Engineering Change Notification

To: All Relevant Customers
From: Newhaven Display Quality Department

NHD-5.0-800480TF-ATXL#-CTP
NHD-5.0-800480TF-ATXL#-CTP-R19
NHD-5.0-800480MB-ATXL-CTP
NHD-5.0-800480FT-CTXL-CTP
NHD-5.0-HDMI-N-RTXL-CTU

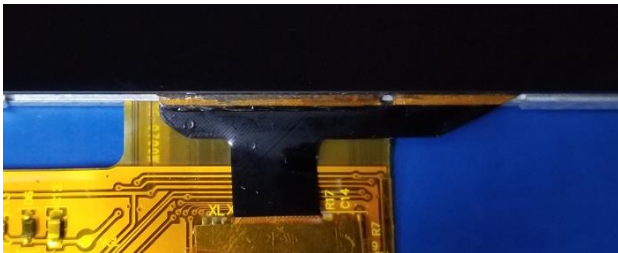
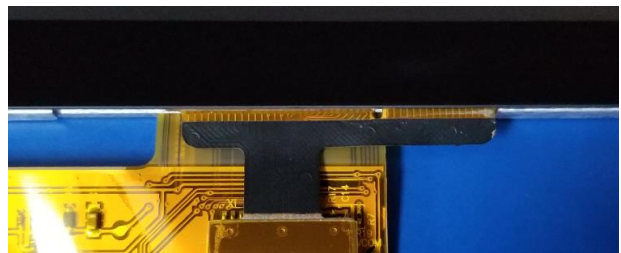
Touch panel's FPC has been redesigned to make it less susceptible to tearing and other damage resulting from improper assembly or handling.

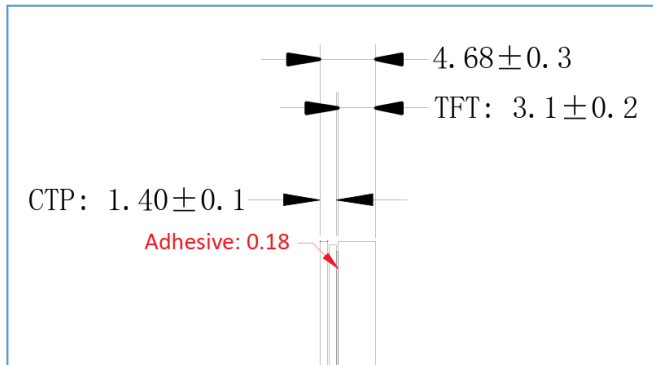
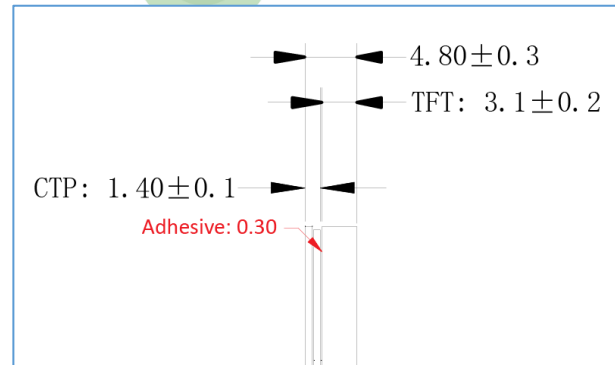
The perimeter bond thickness between the touch panel and display has been increased from 0.18mm to 0.3mm. This results in the overall module thickness to increase from 4.68mm to 4.80mm $\pm$ 0.3mm.
